**BASELINE MONITORING
DOCUMENT AND AS-BUILT
BASELINE REPORT
FINAL**

BUCKWATER MITIGATION SITE

RE: Task 6 As-Built Baseline Report - Buckwater Mitigation Site, DMS ID# 97084
Neuse River Basin – CU# 03020201
Orange County, North Carolina
Contract No. 006829

We have reviewed the comments on the As-Built Baseline Report for the above referenced project dated August 21, 2019 and have revised the report based on these comments. The revised documents are submitted with this letter. Below are responses to each of your comments. For your convenience, the comments are reprinted with our response in italics.

Buckwater Mitigation Site
Orange County, North Carolina
 Buckwater Creek Reaches 1, 2 & 3
 Stream Plan and Profile

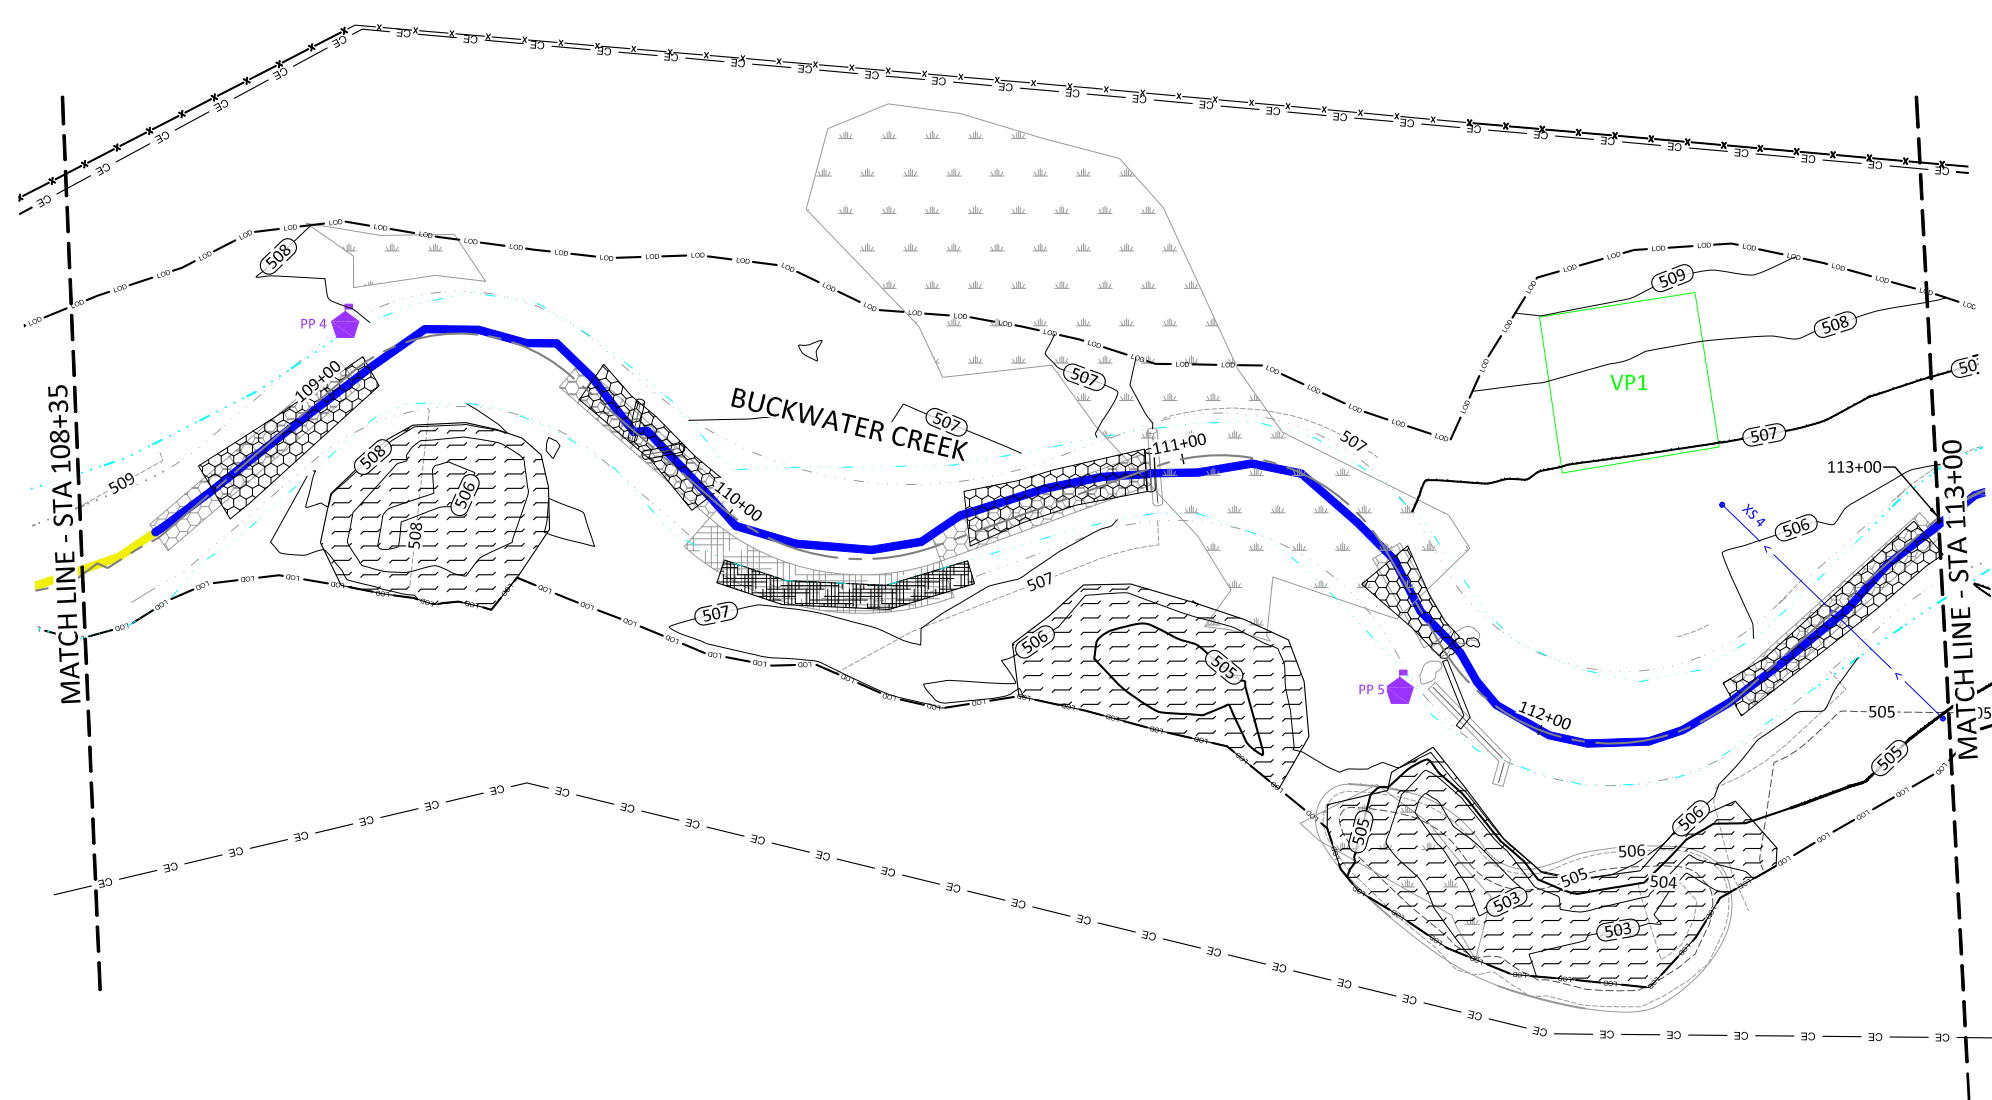
- c) Sheet 1.2: Note says, "STA 104+58: RIFFLE WAS INSTALLED UPSTREAM." However, riffle is not identified in red.

The designed constructed riffle is on sheet 1.2, but the as-built constructed riffle is on sheet 1.1 and shown in red. A note is shown on both sheet 1.1 and 1.2 documenting the change in this constructed riffle.

1.65

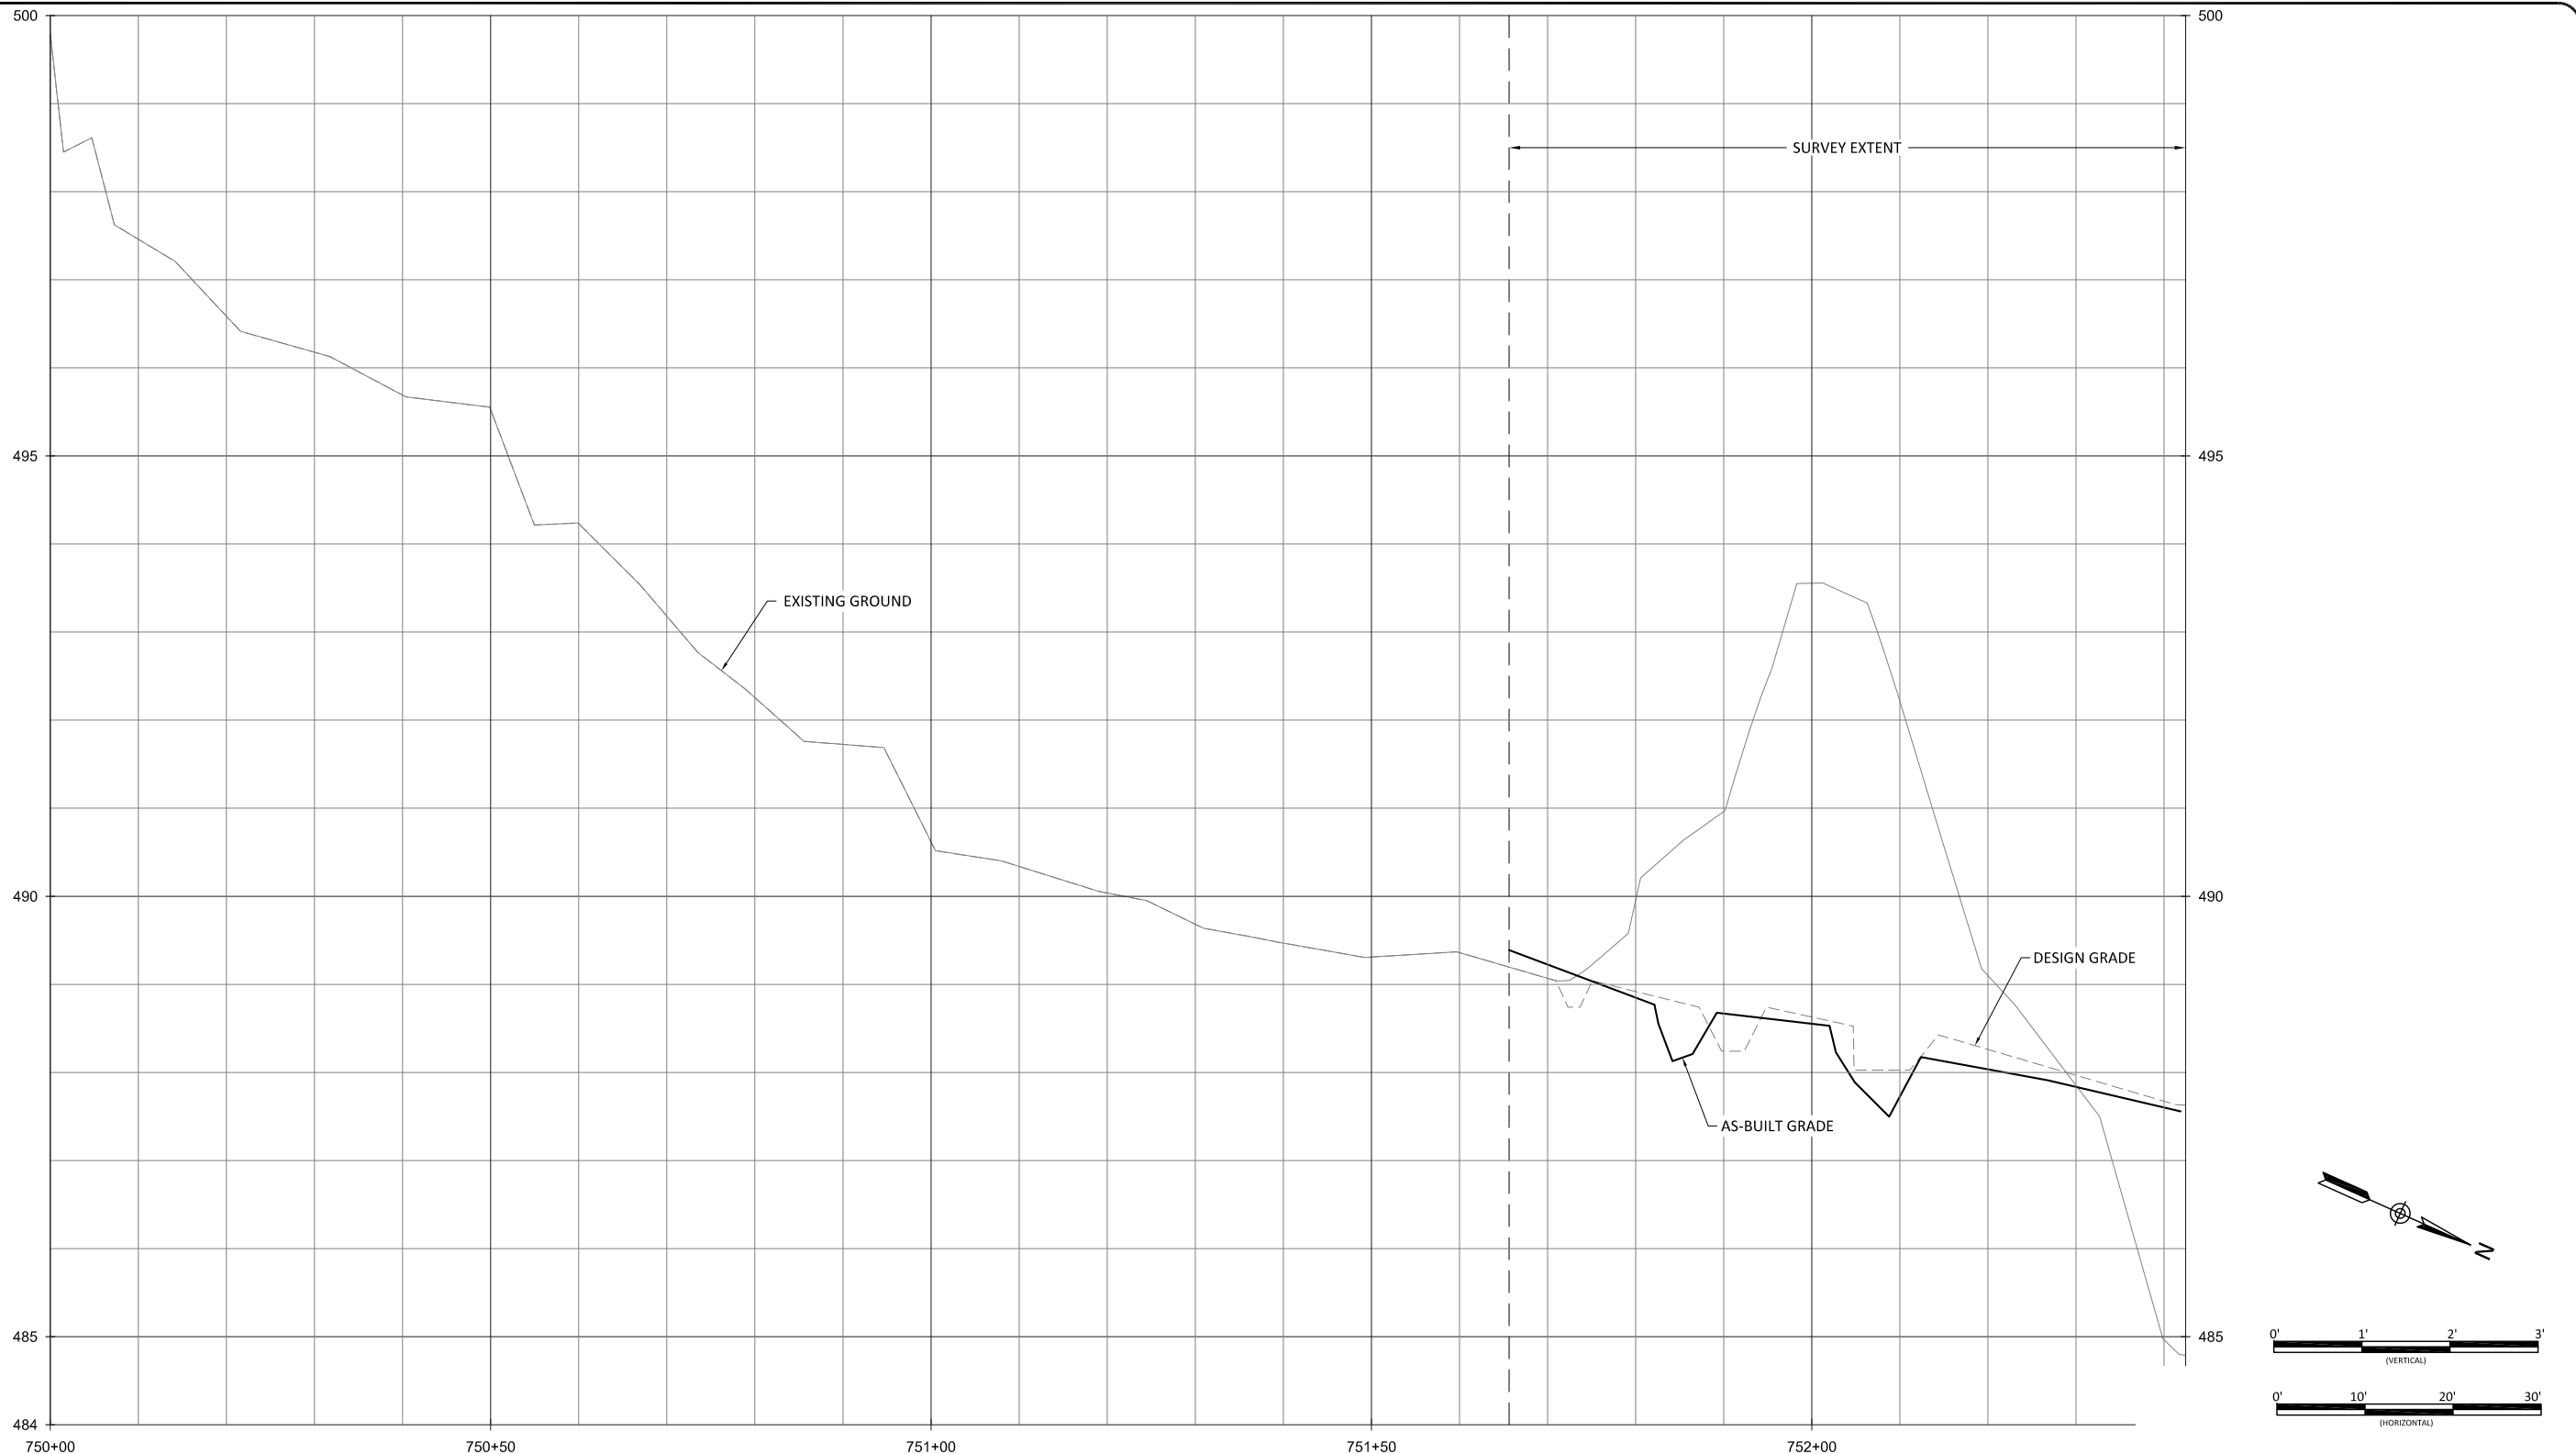
- d) Sheet 1.65: Note says STA 711+17: LOG SILL NOT INSTALLED AND TWO RIFFLES MADE INTO ONE." The two combined riffles should be identified in red graphically.
